TRANS/WP.29/1018 22 September 2004

World Forum for Harmonization of Vehicle Regulations (WP.29)

DRAFT 10 SERIES OF AMENDMENTS TO REGULATION No. 13

(Braking)

"DIAGRAM 2

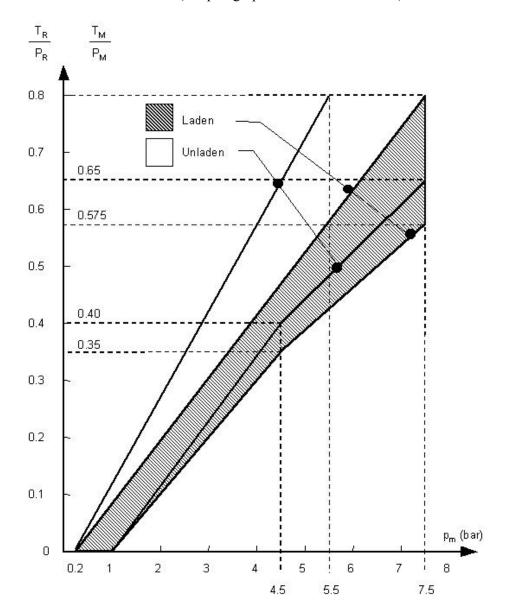
Diagrams 2, 3 and 4A, amend to read:

<u>Note</u>: The relationships required by the diagram shall apply progressively for intermediate states of loading between the laden and the unladen states and shall be achieved by automatic means.
